# CENTRAL COAST COUNCIL

## DEVELOPMENT APPLICATION ASSESSMENT REPORT

<b>Application Number</b>	DA/89/2024
---------------------------	------------

<b>Proposal</b>	Secondary Dwelling
<b>Application Type</b>	Development Application – Local
<b>Application Lodged</b>	05/02/2024
<b>Applicant</b>	Ian Cubitts Classic Home Improvements Pty Ltd
<b>Estimated Cost of Works</b>	\$206686

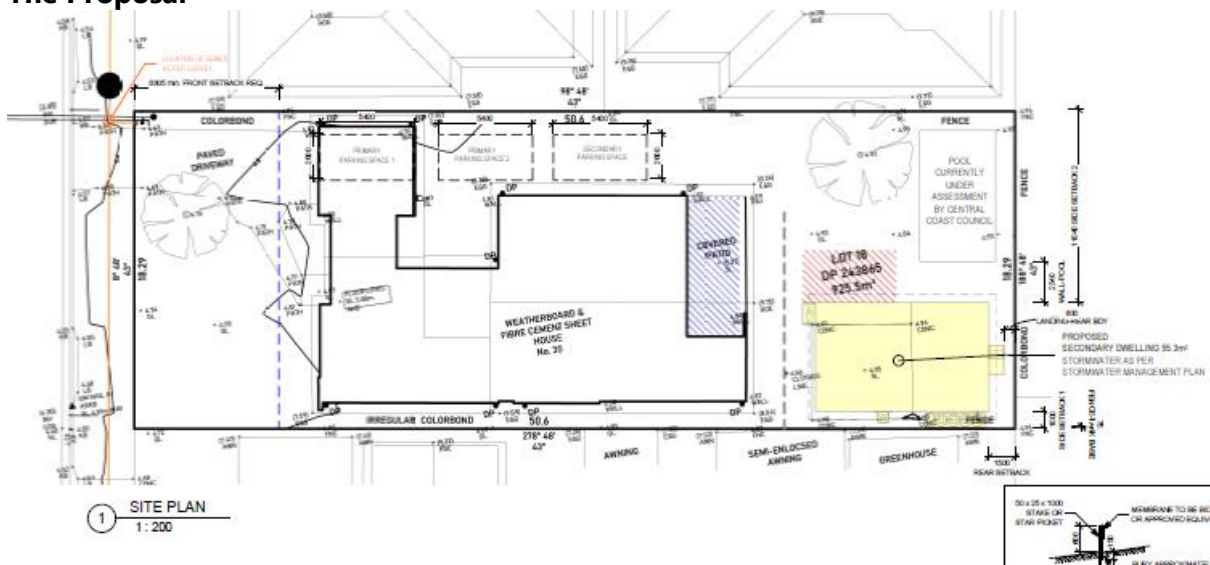
The proposal involves the construction of a Secondary Dwelling to the rear of the existing site.

The submitted secondary dwelling is proposed as a suspended structure (bearers and joists) with a complete open underfloor. The proposed minimum floor level is RL 5.60m AHD.

This type of structure with a FFL of RL 5.60m AHD is supported by Council’s Development Assessment Engineering.
